Memorandum

To:	Mr. Greg Wands Chair, Ashland Conservation Commission	Project Number:	24142
From:	Will Park, PE	Date:	12/23/2025
Project Name:	61 Waverly Street – Notice of Intent		
RE:	Response to Comments - Hearing 1/5		
Distribution:	Israel Lopez - The Gutierrez Company, Mark Arnold - Goddard Consulting, Luke Norton & Corinne Disenhof - Sanborn Head & Associates

THE RESIDENCES AT ASHLAND
61 WAVERLY STREET
ASHLAND, MA

EXISTING HYDROLOGY MAP

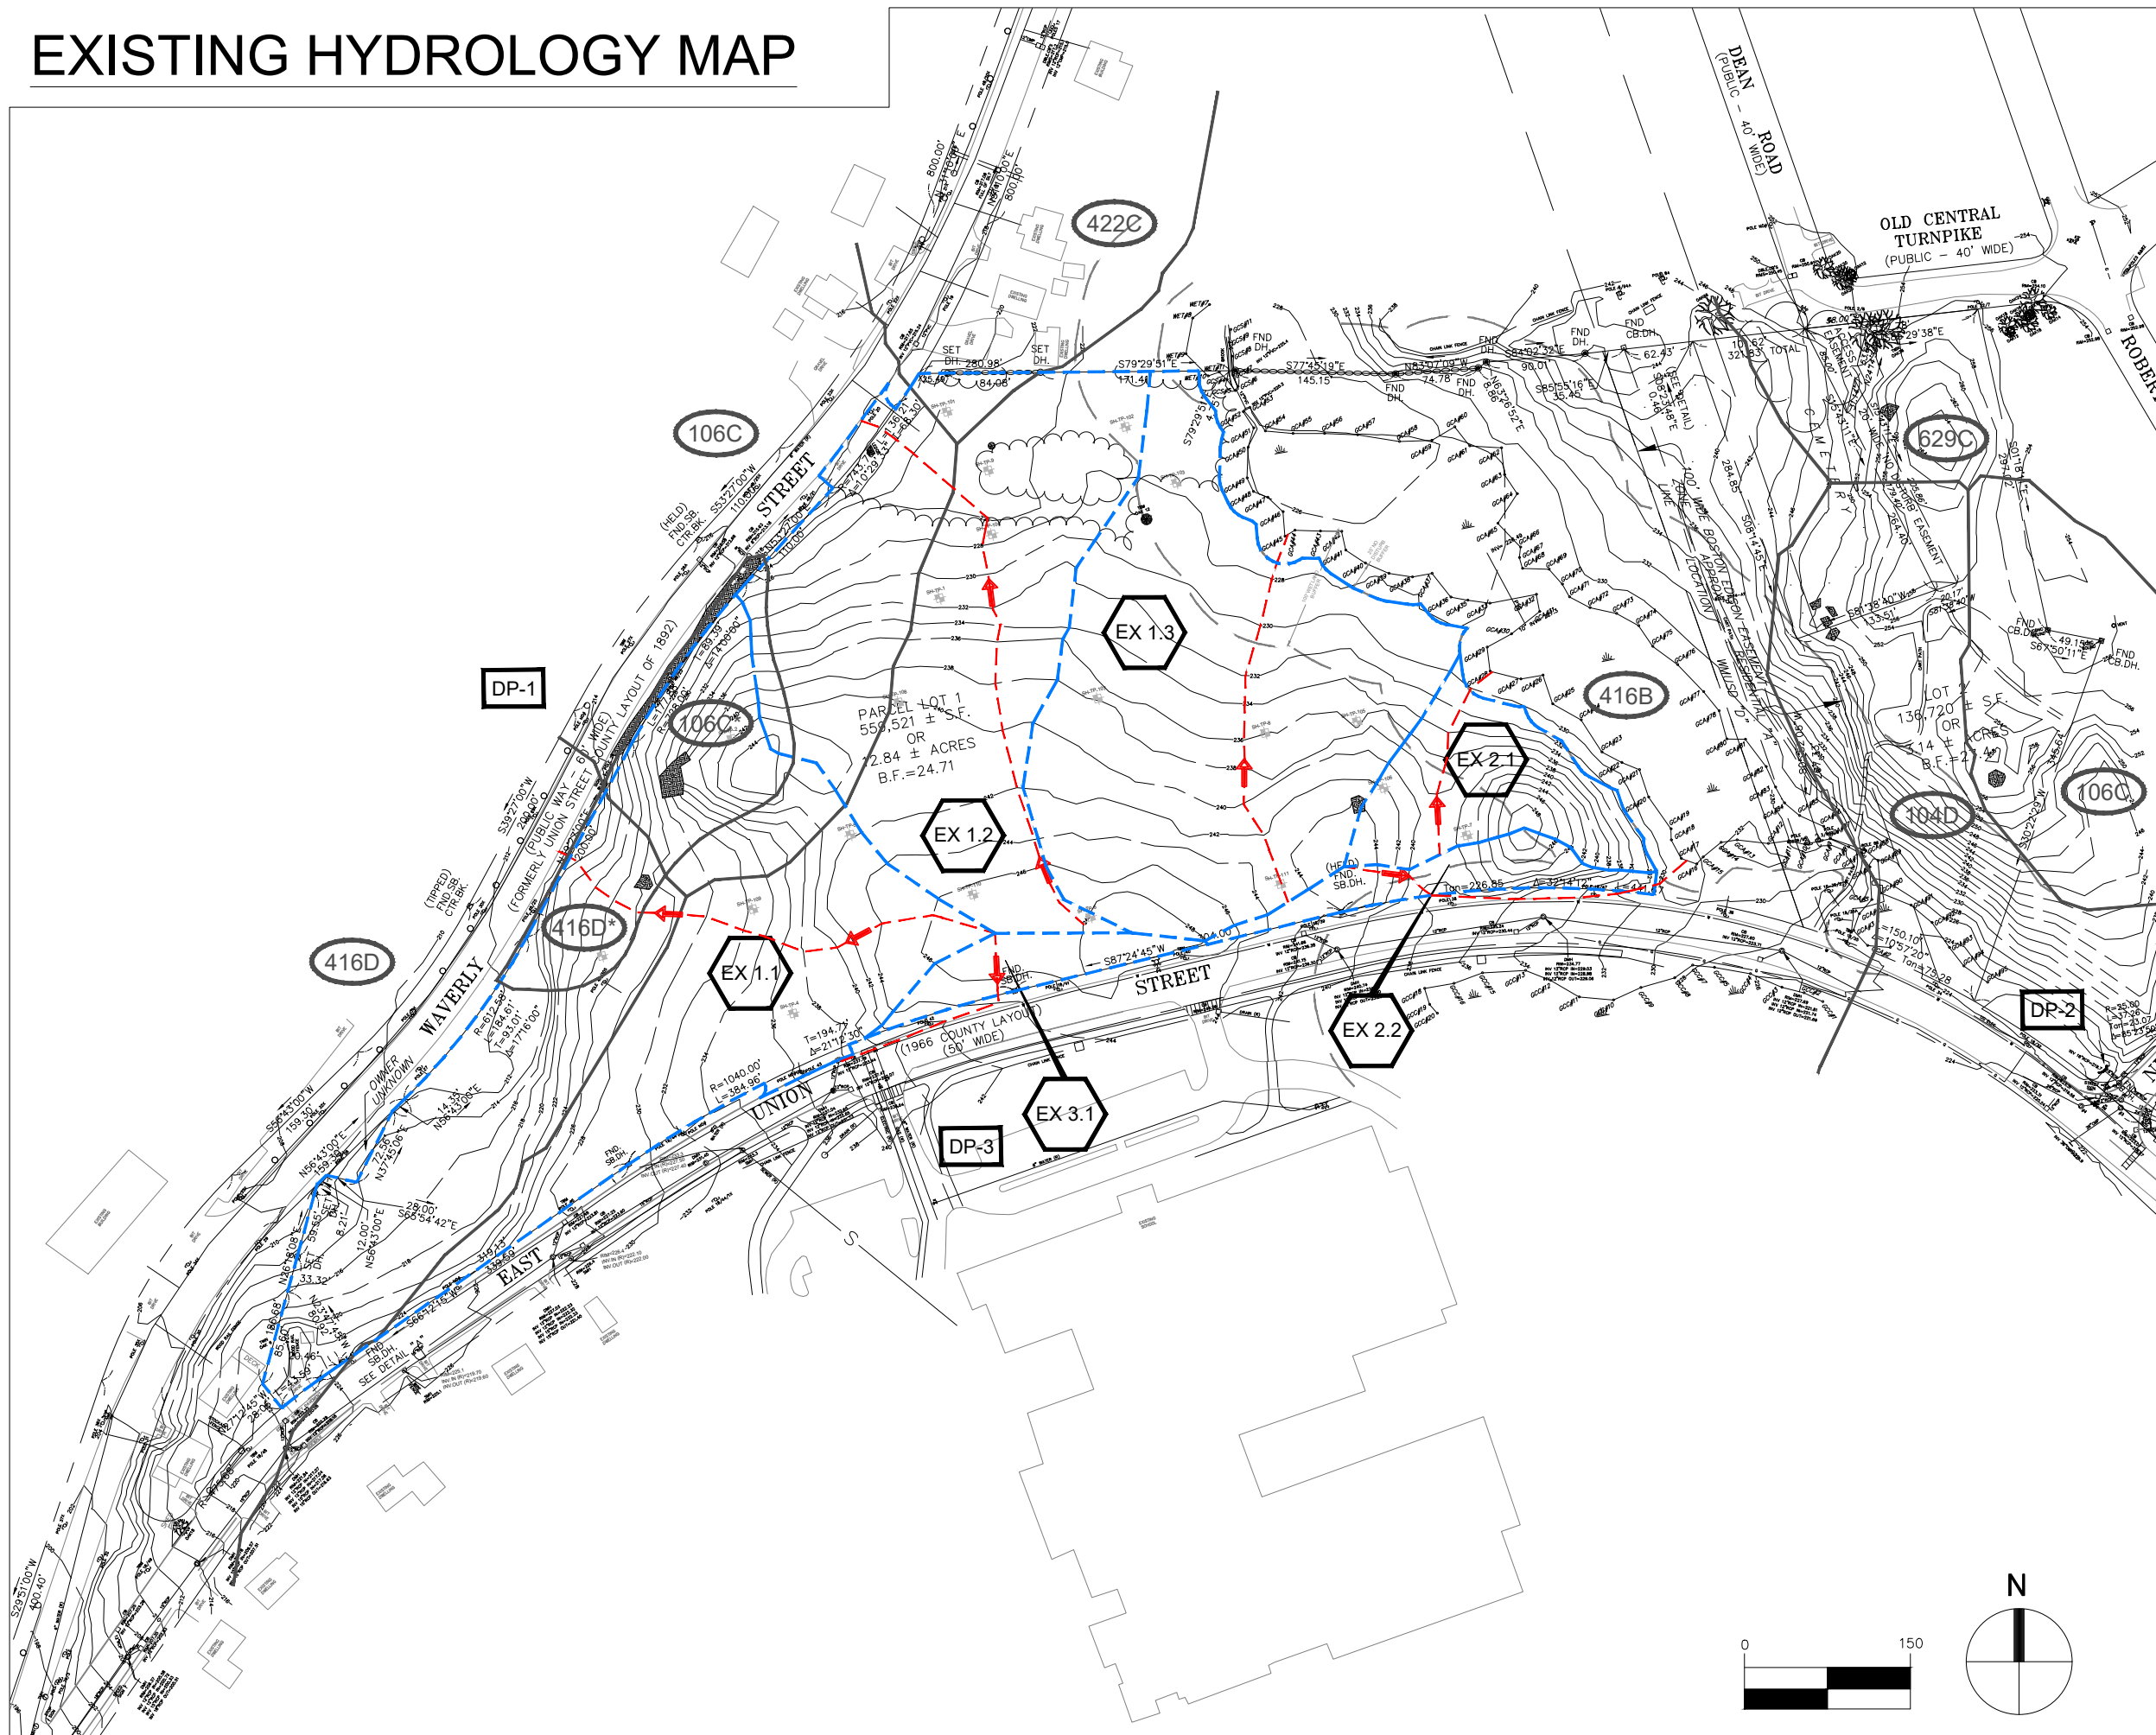
The Conservation Commission has expressed concern regarding the presence of bedrock on the project site and specifically, whether stormwater runoff is discharging from the site over the bedrock slope along Waverly Street. Additionally, we received written comments from the Conservation Agent regarding the hydrological soil group classification used in the stormwater model. The project team has taken these concerns into consideration and re-examined the Hydrologic Soil Group (HSG) of the onsite soils. Refer to the enclosed letter from SHA regarding an area of the site where the previously submitted USDA Web Soil Survey soil series of "Narragansett Silt Loam" with a HSG A is now more accurately classified as HSG A/D. Enclosed are updated Existing and Proposed Hydrology Maps that identify these areas noted with an asterisk on the plan and legend.

The existing hydrology model has been updated with a conservative HSG B designation as HydroCAD does not have a HSG A/D option. As a result, the existing peak discharge rates have increased slightly. No other changes to the stormwater model have been made

at this time. Complete HydroCAD models and supporting calculations will be submitted after responses to the Conservation Commission’s peer reviewer comments have been addressed.

EXHIBIT: BEDROCK ELEVATION PLAN/PROFILE (APPROX.)

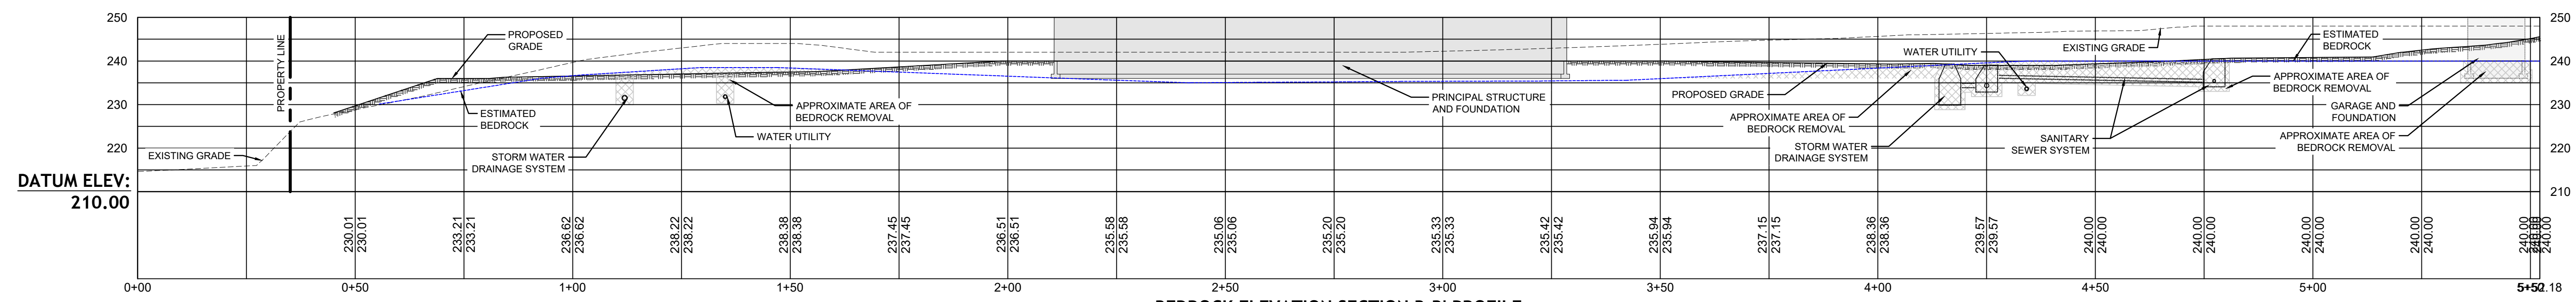
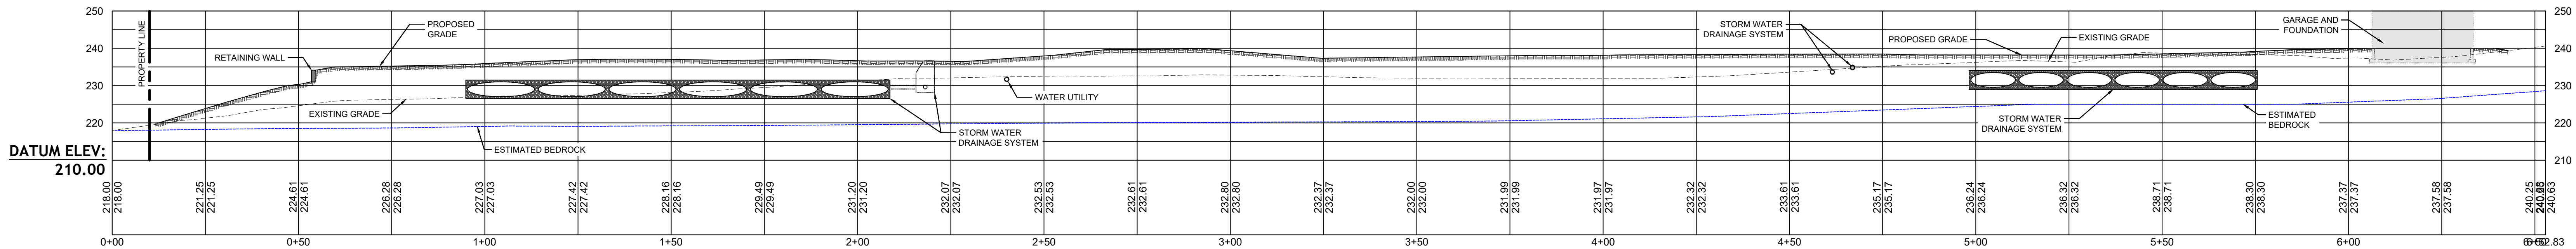
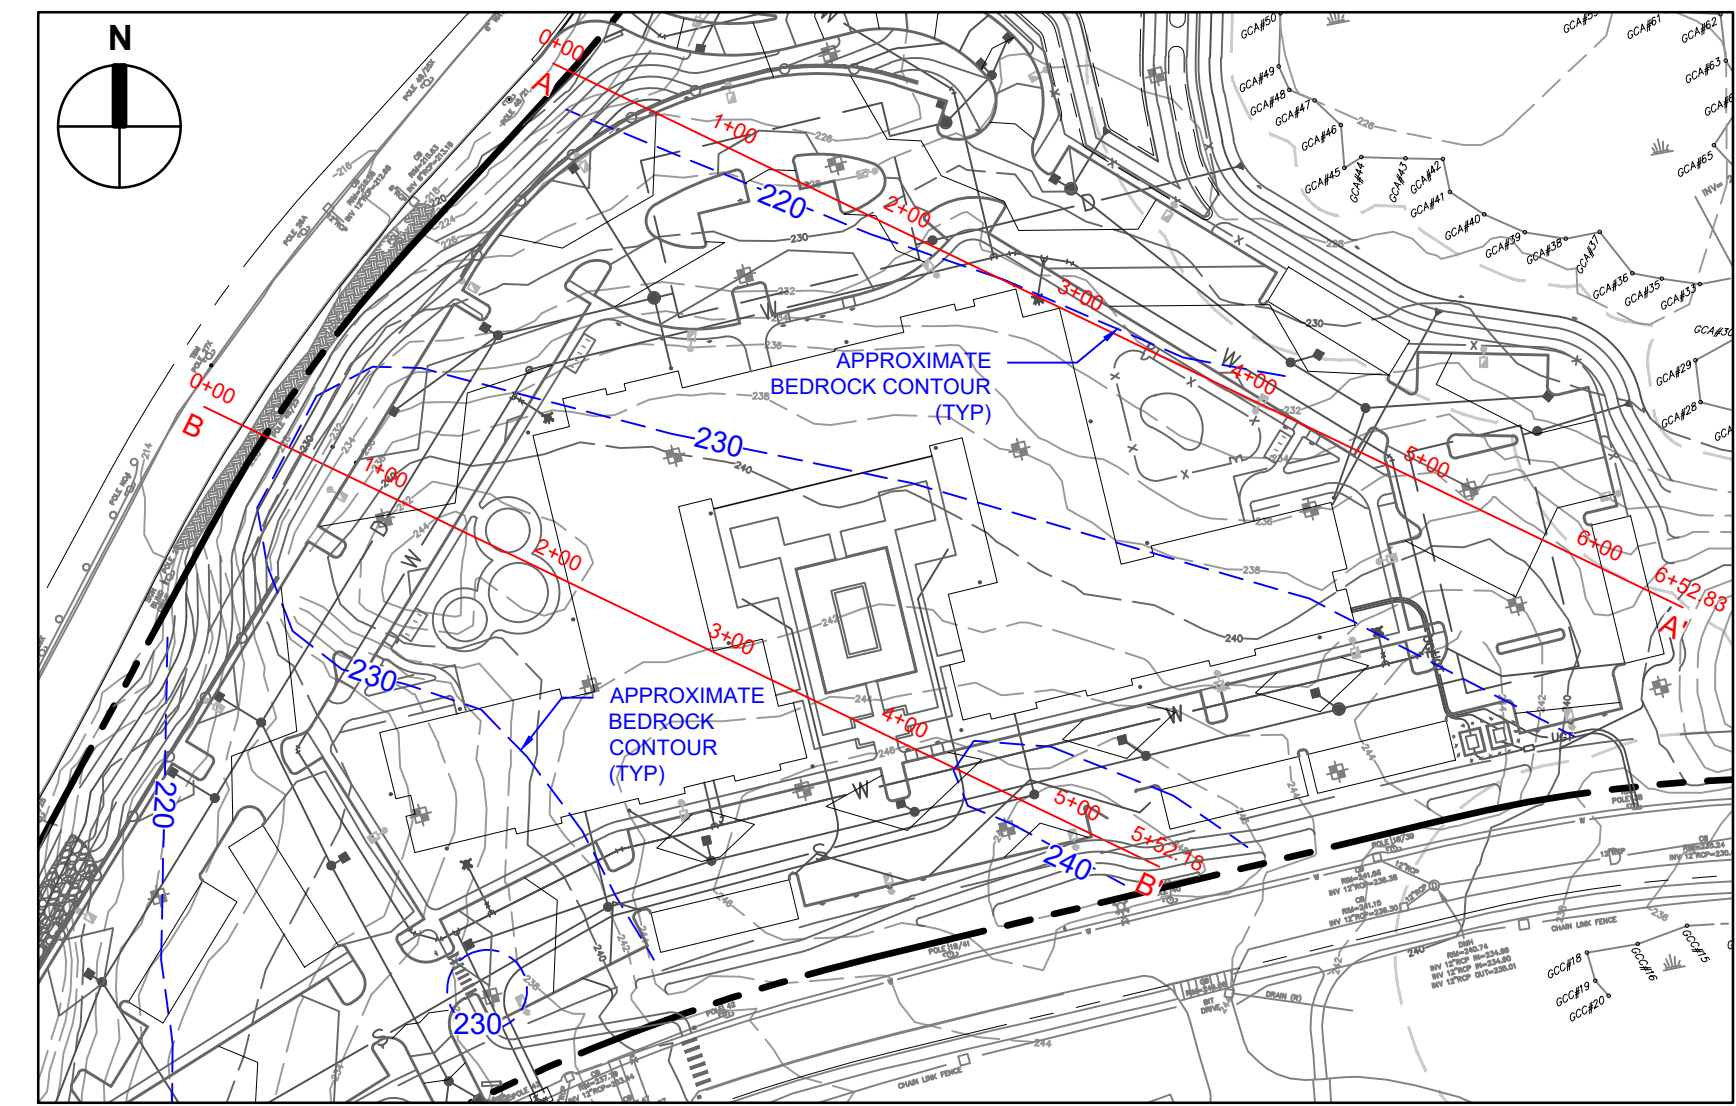
Bedrock Removal

Refer to the enclosed letter from SHA regarding the bedrock observed on the project site, anticipated areas of limited bedrock removal, and possible means of removal.

Enclosed is Exhibit: Bedrock Elevation Plan/Profile (Approx.) that shows the limited bedrock removal. Profile "A" demonstrates the more typical project earthwork scenario where bedrock removal is not anticipated. Profile "B" demonstrates the "worst case" through the bedrock ridge as described by SHA.
